Special inspection to increase the TBO for engine

Mandatory

- Subject:** Increase of TBO from 600^h/10 years to 1000^h/10 years.
- Engines affected:** Generally all engines of Series Type 912 A up to and including engine N. 4,380.693 in accordance with Type Certificate TW 8/89, with the exception of V912/1983, V912/1920, 3,792.605, 3,792.701, 3,792.788, 3,792.789, 3,792.790, 4,005.013, 4,005.083, 4,005.133. From engine N. 4,076.192 onwards the 1000^h TBO is covered by TM 912-04.

2.1) Friction washer, amendment no. 15:

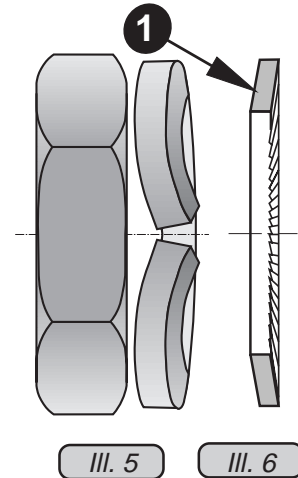
If hex. nut is still secured by a lock washer, it has to be exchanged for the friction washer ①. Slide drive gear of the exchange gearbox on cleaned serration of crankshaft and fit friction washer and hex. nut M30x1,5.

■ **ATTENTION:** Secure hex. nut with LOCTITE 221. Hex. nut with L.H. thread.

3) Oil pump amendment no. 17, 22 and 32-17:

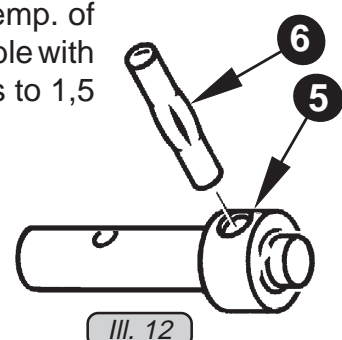
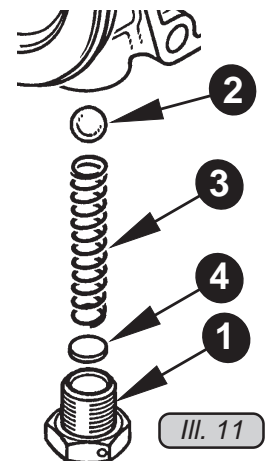
Remove plug screw ① of pressure relief valve ②, clean valve and check ball seat in housing. Clear all oil passages by compressed air. From engine serial no. 4,005.186 onwards, to improve oil pressure control the following parameters of the relief valve were changed. Free length of the compression spring ③ was reduced from 46 mm to 39,5 mm. Spring rate was changed by increase of wire dia. from 0,8 mm to 0,9 mm, and dia. of ball was increased from 8 mm to 8,5 mm.

◆ **NOTE:** Starting with engine N. 3,792.944 the oil pump housing and oil pump cover is in pressure die cast. On this occasion capacity of the pump was increased by lengthening of the rotary piston assy. from 13 mm to 16 mm along with the respective changes of oil pump housing, pump shaft and O-rings.

From engine serial no. 4,076.068 onward the follower in the oil pump shaft ⑤ was changed to notched pin ⑥ instead of the former dowel tube.

At a renewal of components change oil pump to the version with the 16 mm long rotors.

4) Rubber plate, amendment no. 32-19

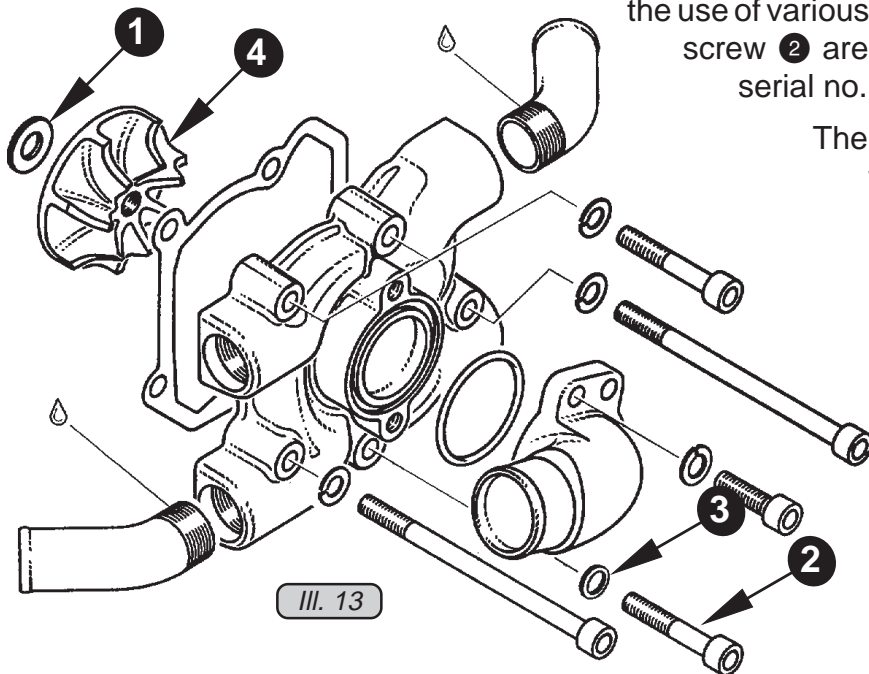
To prevent chafing of the expansion tank a protective rubber plate is glued to underside of expansion tank since May 1993. Inspect expansion tank and stick rubber plate to underside of tank.

5) Water pump, amendment no. 35-02

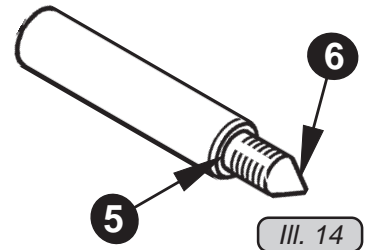
At engine operation without antifreeze in the coolant, increased formation of corrosion takes place. Therefore the material of the pump shaft was changed with engine serial no. 4,076.122. Because of galvanic reactions, caused by

the use of various materials, the washer ① and the screw ② are of stainless steel since engine serial no. 4,076.178.

Check water pump shaft at runout of thread ⑤ for possibly existing corrosion. At bad corrosion renew water pump shaft. For this renewal remove ignition housing and fit new water pump shaft as per instructions in the Repair Manual.

Note: The new shaft can be recognised by a taper ⑥.

6) Carburettor

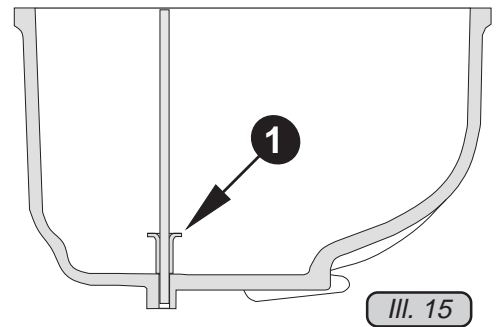
Remove float chamber and lift out both floats. If float chamber is still without distance pieces ①, part no. 861 920, add them now, thus avoiding possible sticking of the floats in the float chamber.

Ill. 15

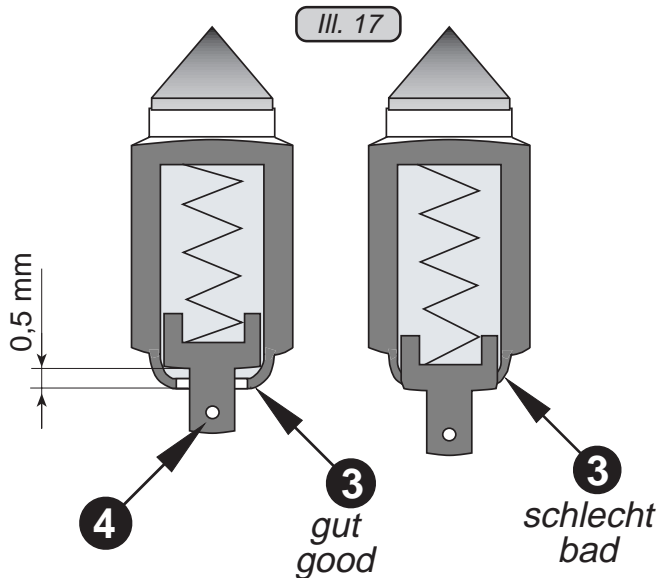
Check support pin ② of floats. At heavy wear of float bracket contact faces, caused by excessive vibration, exchange these floats to floats of modified shape ⑤, part no. 861 181 as per amendment no. 37-01 and renew float bracket as required.
